Aug 24, 2018

Motor Business Unit,
Electromechanical Control Business Division,
Automotive & Industrial Systems Company,
Panasonic Corporation

Software Upgrade Notice
for AC Servo Driver (MINAS A6SE/A6SF/A6SG Series)

No. 2) Setting range extension of analog input (AI1, AI2, AI3) offset

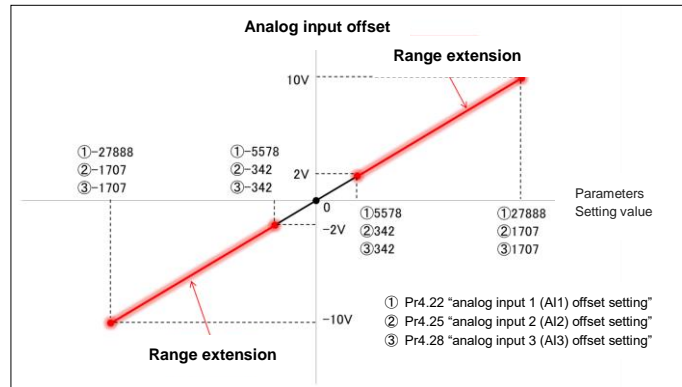
The setting range of offset adjustment value (Pr4.22, Pr4.25, Pr4.28) to the voltage applied to the analog input (AI1, AI2, AI3) has been expanded as follows.

±2V (Pr4.22: -5578 ~ 5578 [0.359 mV],
 Pr4.24, Pr4.28: -342 ~ 342 [5.96 mV])

↓
 ±10V (Pr4.22: -27888 ~ 27888 [0.359 mV],
 Pr4.24, Pr4.28: -1707 ~ 1707 [5.96 mV])

(Please see the chart to the right.)

Because this is an expansion of the set range, use of this function, as before, is possible without a change.
